TECHNICAL INFORMATION

60024

Subject ▶ Change of the Component Parts for Depth Adjustment

For Models ▶ 6833, 6834

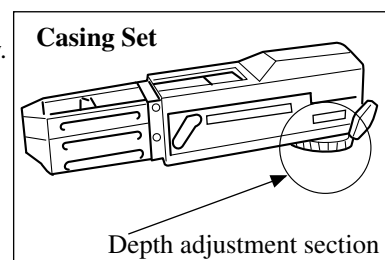
Description ▶ 1) Knob 42 and other component parts for depth adjustment have been changed for standardization as illustrated below. The new parts are identical with those of Model 6835DW.
2) And accordingly, Casing Set for Model 6833 that includes these parts has been changed at the same time.
(The new Casing Set of Model 6833 is identical with that of Model 6835DW.)
However, the part no. of Casing Set for Model 6834 remains unchanged.

For Model	► Current	► New
1) Components for depth adjustment	6833 6834	<p>Knob 42 (416517-7) Compression Spring 12 (233089-5) Sleeve 4 (257694-4) Flat Washer 6 (267117-4)</p>	<p>Knob 42 (417056-0) O Ring 11 (213105-9) Flat Washer 6 (267201-5)</p>
2) Casing Set	6833	Part 192849-3 for all countries except European countries	Part 193024-4 for all countries except European countries
		Part 192850-8 for European countries	Part 193025-2 for European countries
	6834	Part 192851-6 for all countries except European countries	Part 192851-6 for all countries except European countries
		Part 192852-4 for European countries	Part 192852-4 for European countries

Item No.	Current part		Q'ty	I/C	New part		Q'ty	Note
6833: 012 6834: 012	Knob 42 416517-7		1	No	Knob 42 417056-0		1	Interchangeable as a set
6833: 013 6834: 013	Compression Spring 12 233089-5		1	No	O Ring 11 213105-9		1	
6833: 075 6834: 074	Sleeve 4 257694-4		1					
6833: 014 6834: 014	Flat Washer 6 267117-4		1	No	Flat Washer 6 267201-5		1	
6833: B01	Casing Set 192849-3		1	Yes	Casing Set 193024-4		1	For all countries except European countries
6833: B01	Casing Set 192850-8		1	Yes	Casing Set 193025-2		1	For European countries
6834: B01	Casing Set 192851-6		1	Yes	Casing Set 192851-6		1	For all countries except European countries
6834: B01	Casing Set 192852-4		1	Yes	Casing Set 192852-4		1	For European countries
